ISO-9650 liferaft — Spares : *Alternative painter activation label*

This Service Bulletin has been technically approved by Survitec Design Authority.

Dated: 04-Jun-2021

FIGURE 1
Painter activation label (old)
P/N E15500126

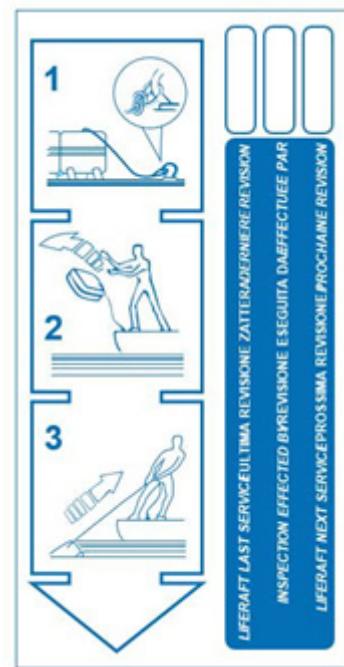
A painter activation label (P/N E15500126) is attached to the fabric valise on ISO-9650 liferafts and gives instructions on how to use the painter line. This label is no longer available. However, Survitec has found an alternative.

The alternative, painter activation label (P/N E15500125) contains the same pictorial content as well as a multi-lingual service record section. When using this label, it must be trimmed so that it has the same finished dimensions as the old label.

From now on, when you need to order a new label, you must order P/N E15500125 (**Figure 2**). Existing stock of E15500126 (**Figure 1**) can still be used.

- A. Obey the correct service manual to service the liferaft.
- B. Remove the old painter activation label.
- C. Trim the new painter activation label so that you can only see the pictorial section. Make sure that the dimensions of the label are 155 × 47 mm.
Refer to **Figure 3**.
- D. Attach the new label to the fabric valise.
